LAND USE APPLICATION SUMMARY

Property Location: 107 6th Street SE and 608 Central Ave NE
Project Name: White Castle
Prepared By: Shanna Sether, Senior City Planner, (612) 673-2307
Applicant: Insites, Inc.
Project Contact: Bob Mueller
Request: To allow for the new construction of a fast food restaurant.
Required Applications:

Conditional Use Permit	To allow a fast food restaurant in the C2 District.
Site Plan Review	For a fast food restaurant with a drive-through facility in a new building.

SITE DEMO PLAN

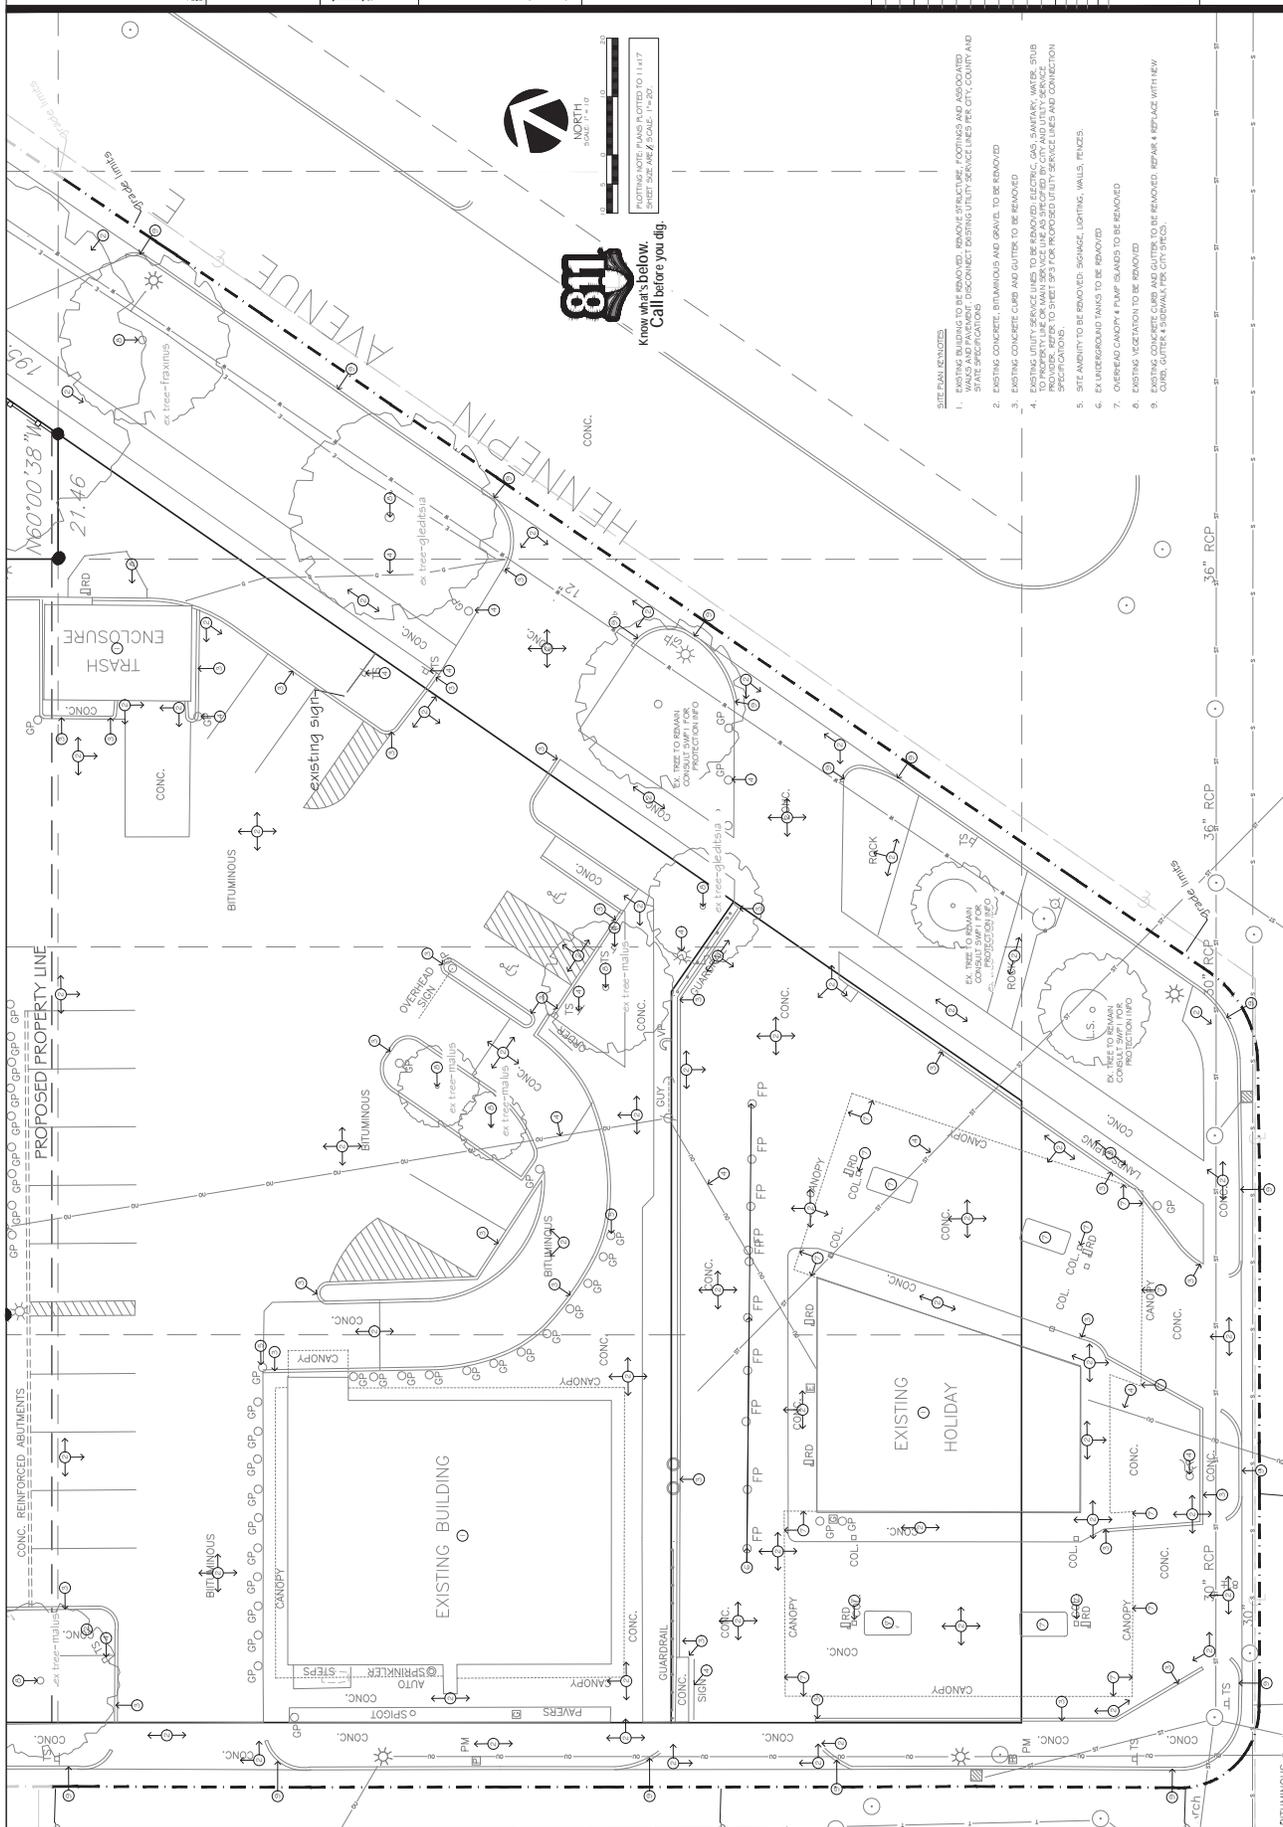
- The demolition plan shall clearly define the limits of disturbance. All existing driveway aprons and all curb & gutter surrounding the site shall be identified for removal. It is recommended that the Applicant consider the removal and replacement of all existing sidewalk surrounding the site. All impacted sidewalks, curbs, and boulevards shall be restored to City standards.

- Based upon the demolition plan provided; rather than leaving small sections of existing curb the Applicant shall provide for removal and replacement of all curb surrounding the site. All curb & gutter in the Public right-of-way shall be designed and constructed to City standards, curb & gutter to be City standard B624 Curb and Gutter. Please refer to the following: http://www.minneapolismn.gov/publicworks/plates/public-works_road. Add the following details from the ROAD-1000 Series - Curbs and Gutters to the plans: ROAD-1003 and ROAD-1010. Top of Curb profiles shall be provided for any section of curb replacement in excess of 50 feet.

FRONT ELEVATION

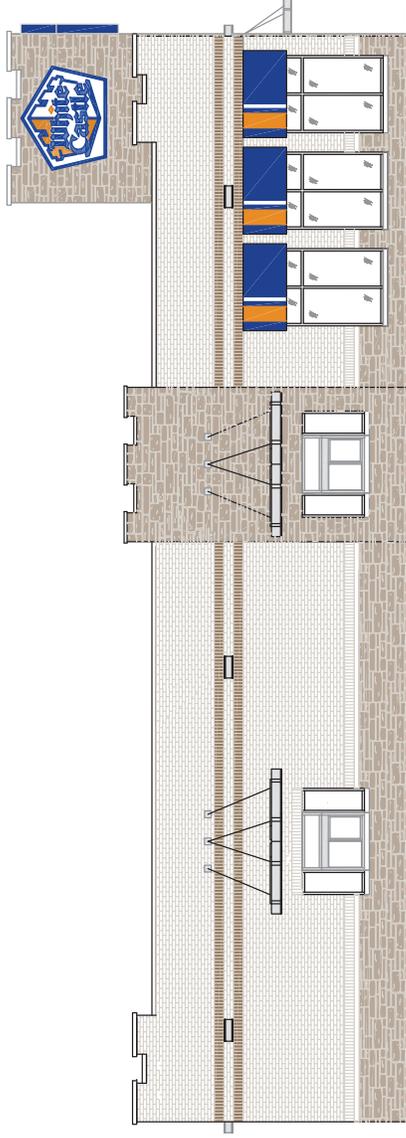
- For nonresidential uses, the zoning code requires that no less than 30 percent of the walls on the first floor are windows with clear or lightly tinted glass with a visible light transmittance ratio of six-tenths (0.6) or higher. The project is not in compliance with the minimum window requirement on the rear elevation(see Table 3) and the applicant is seeking alternative compliance. The applicant has stated that the rear of the building is devoted to cold storage and they are not proposing any windows on the rear elevation. As an alternative, the applicant is proposing to add outdoor seating area to the right-of-way abutting 6th St SE and landscaping trellis to add visual interest. Staff is recommending that the planning commission grant alternative compliance.

REAR ELEVATION

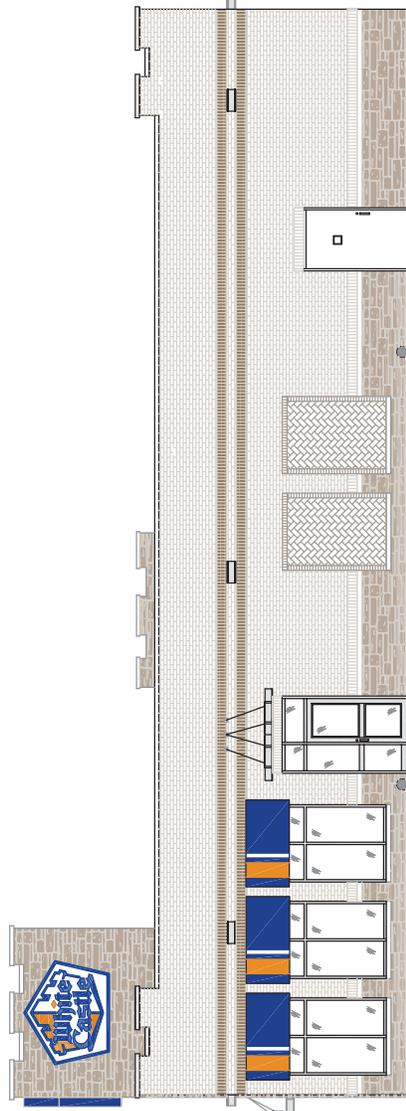
- **30% windows facing east.** The project is not in compliance with the minimum window requirement on the rear elevation and the applicant is seeking alternative compliance. The applicant has stated that the rear of the building is devoted to cold storage and they are not proposing any windows on the rear elevation. As an alternative, the applicant is proposing to add outdoor seating area to the right-of-way abutting 6th St SE and landscaping trellis to add visual interest. Staff is recommending that the provide an additional trellis on the East elevation of the building as an additional alternative and the planning commission grant alternative compliance.
